Structural Assessment
Garberville Veterans Building
Garberville, CA

KPFF Consulting Engineers
San Francisco, CA
February 26, 2021

STRUCTURAL ASSESSMENT

**CONCEPTUAL SKETCHES:
ROOF PLAN
KPPF**

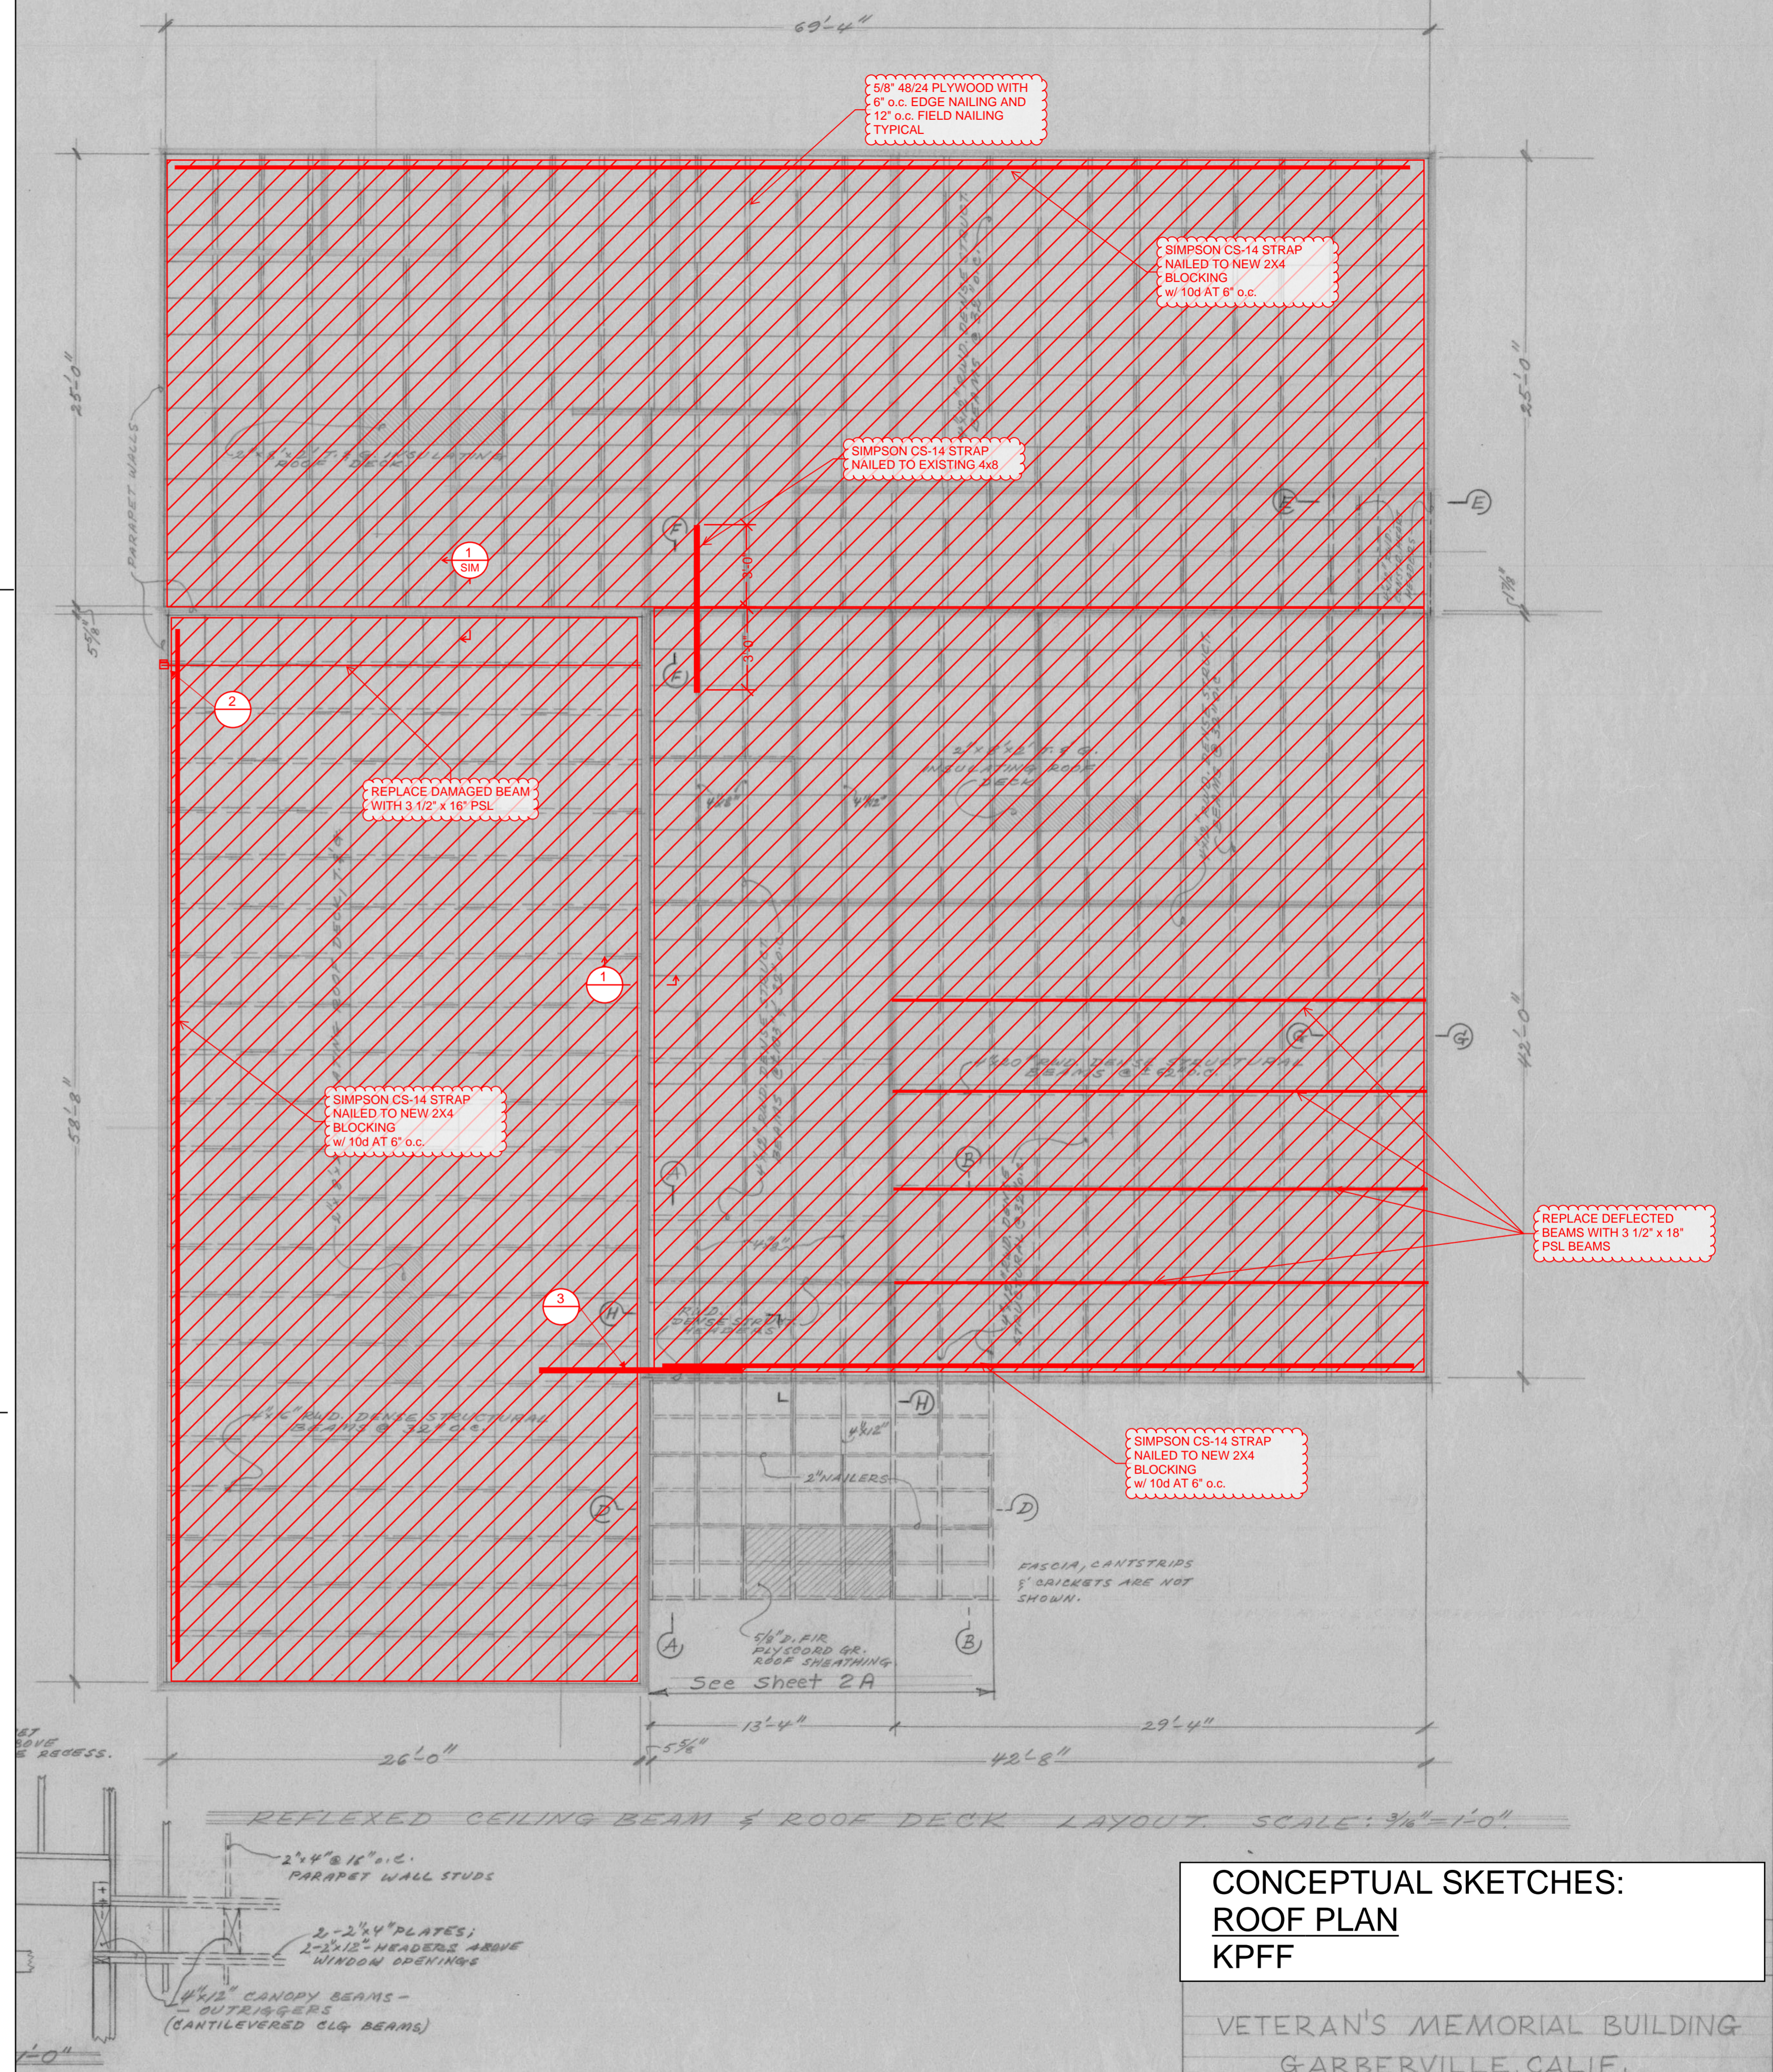
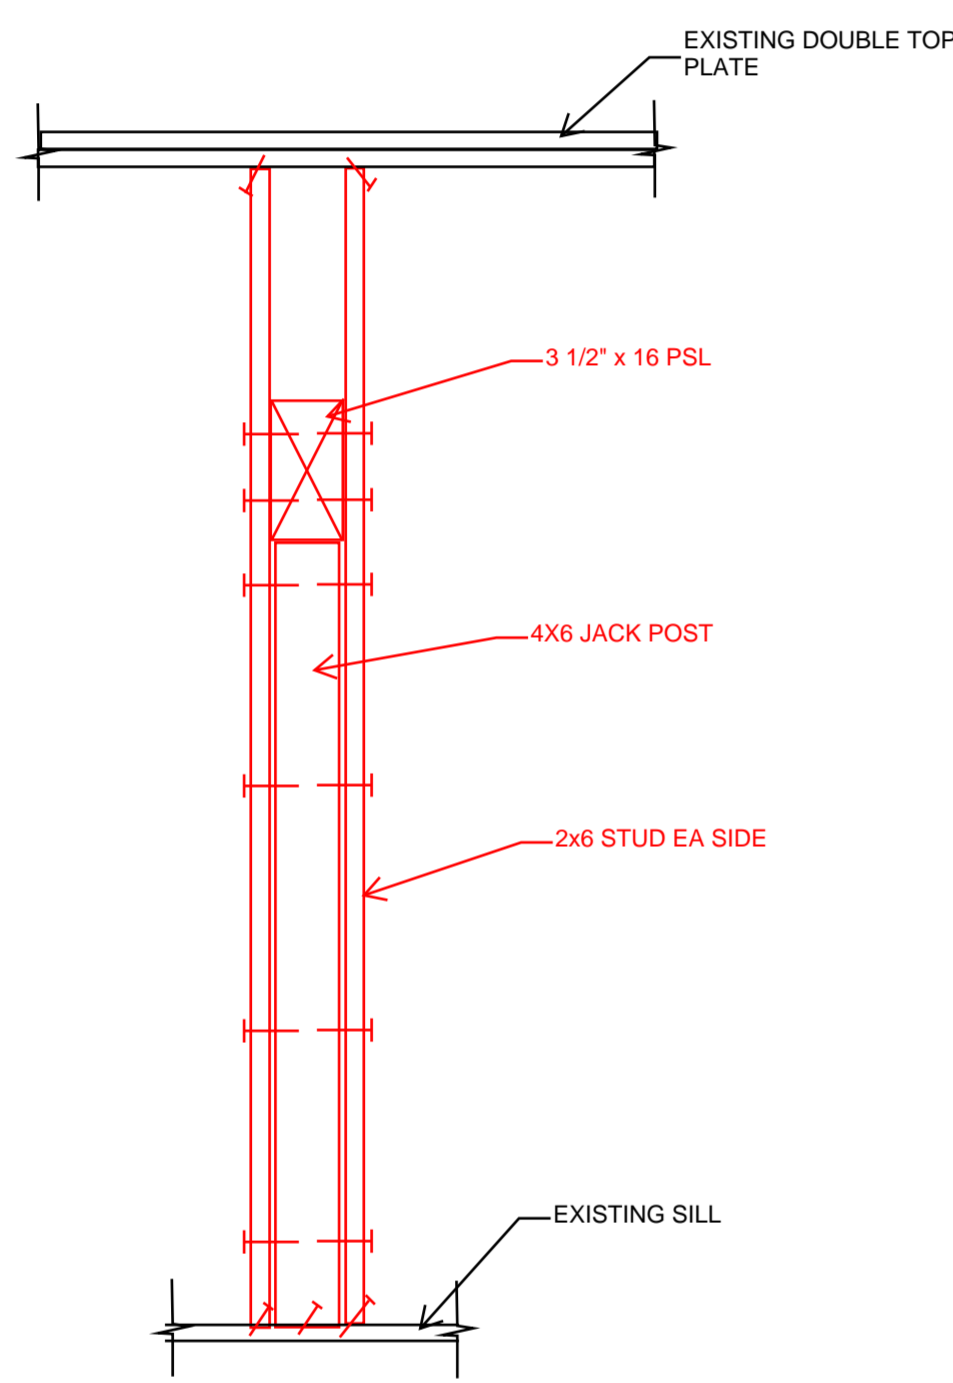
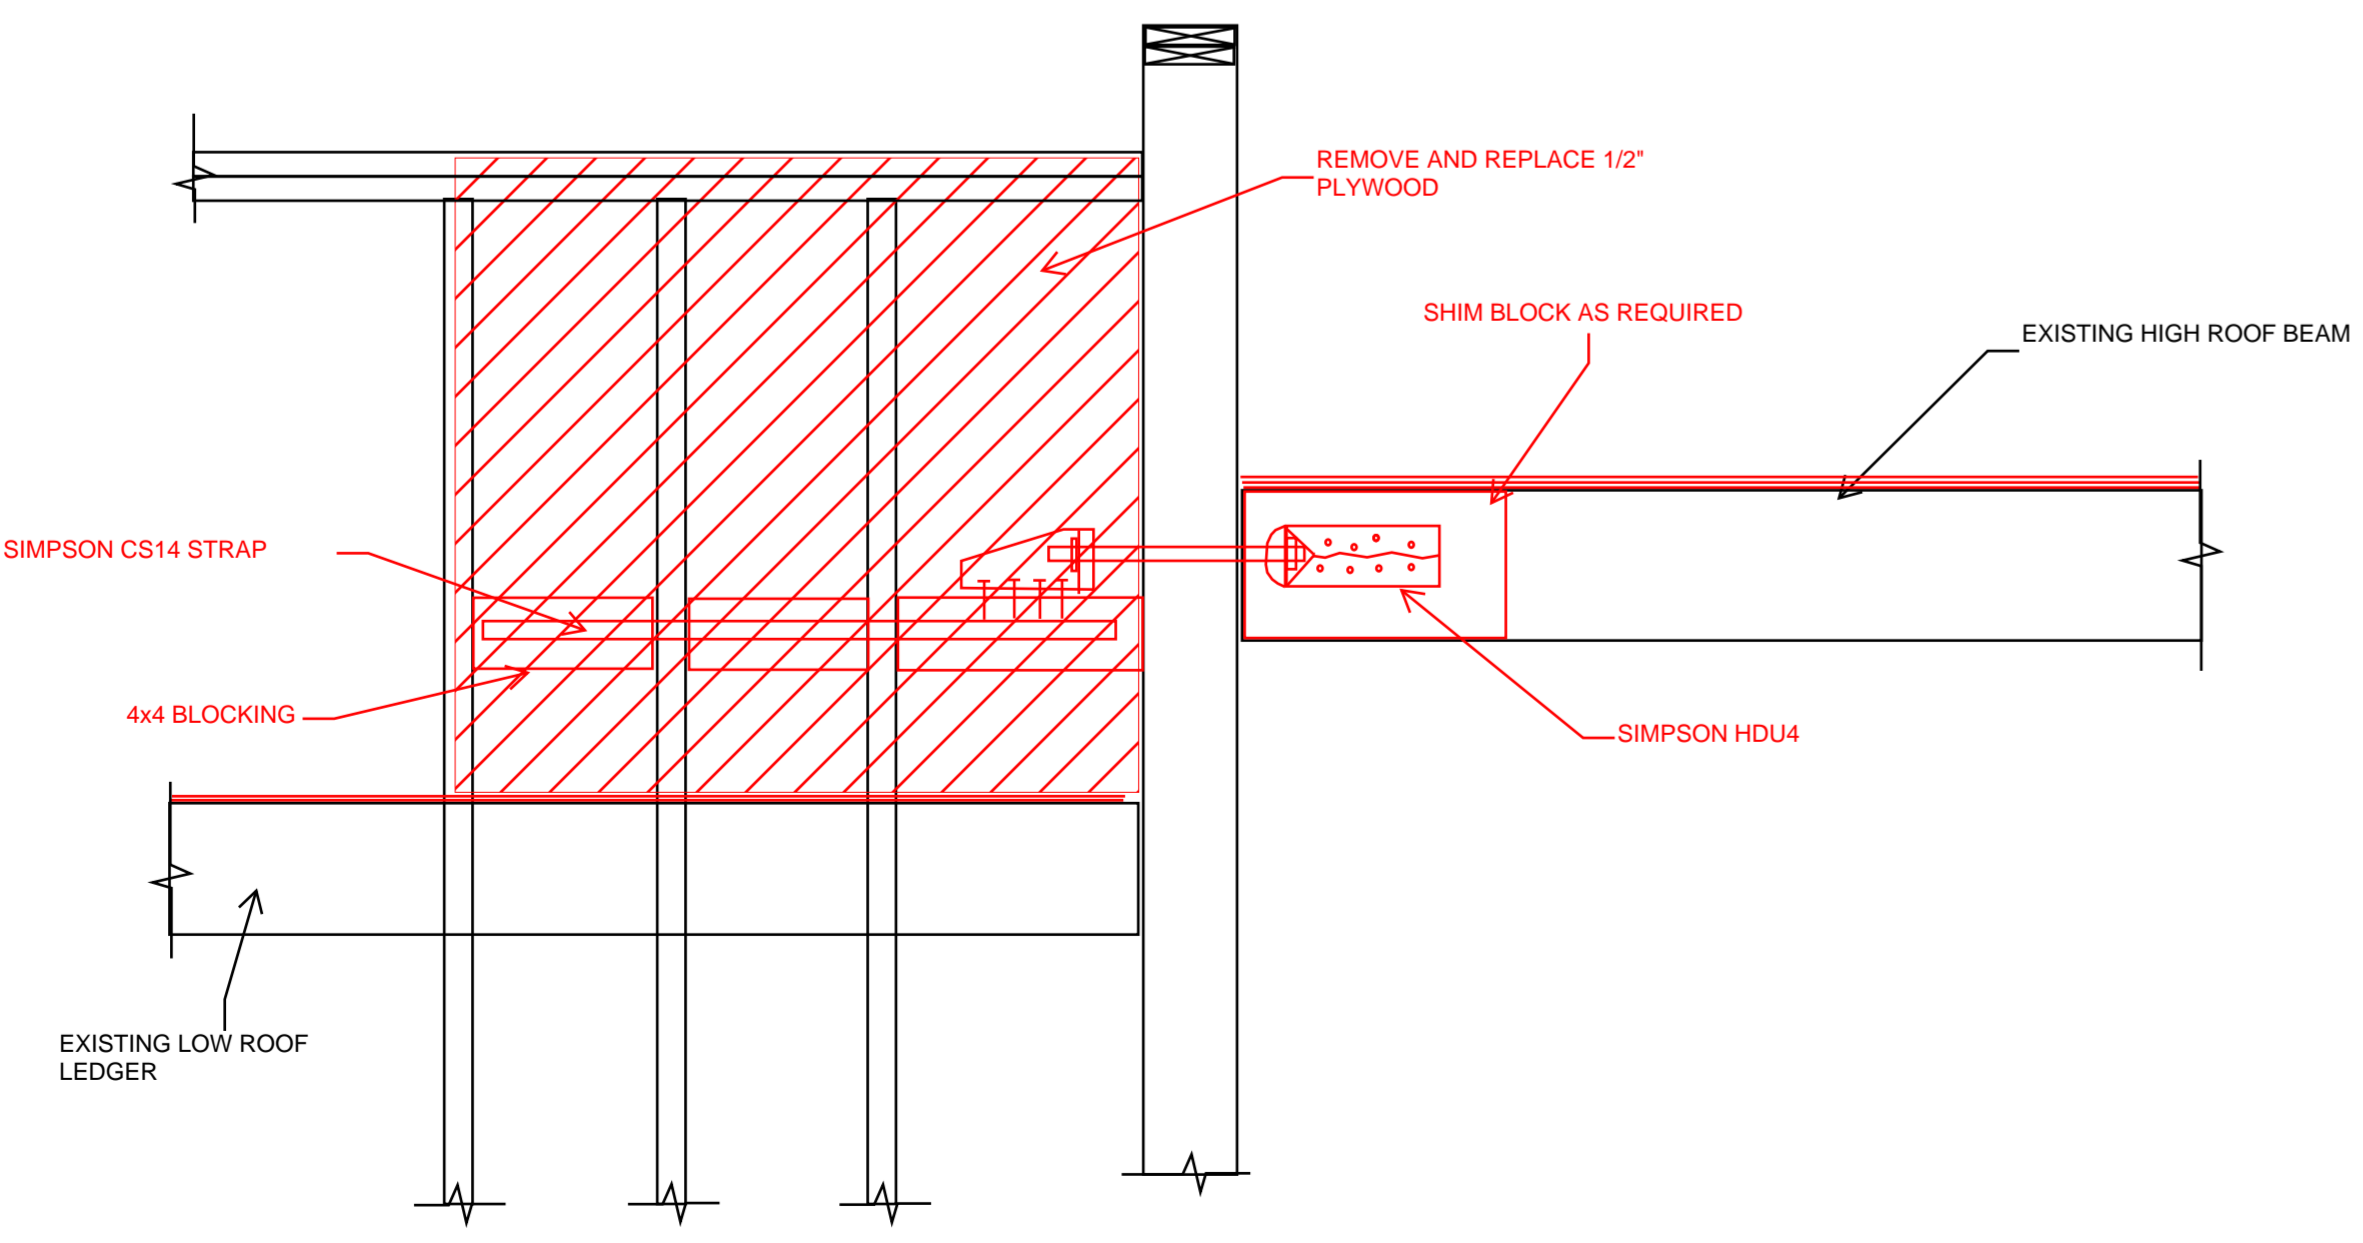
- 7.2 Remove the insulating fiberboard roof diaphragm and replace with 5/8" CDX plywood sheathing, APA rated 48/24. A ledger and blocking along perimeter walls will be required for diaphragm shear nailing. Add metal straps and blocking at the steps in the roof diaphragm to provide continuous chords. Straps will also be required as continuous drag elements where the framing runs perpendicular to the walls. Where the walls run parallel to the framing, drawings appear to indicate that there is a continuous ledger along the wall that can serve as a drag.

- 7.3 Replace the damaged beam and parapet studs in the auditorium. Remove the finishes at other water damaged locations and inspect the structural members for rot, replacing members as needed. The typical connections between roof beams and walls are unconventional compared to today's construction standards but are acceptable provided that the members are found to be in good condition. In the case of the damaged beam in the auditorium, the entire connection was deteriorated, and we have provided a conceptual detail for replacement.
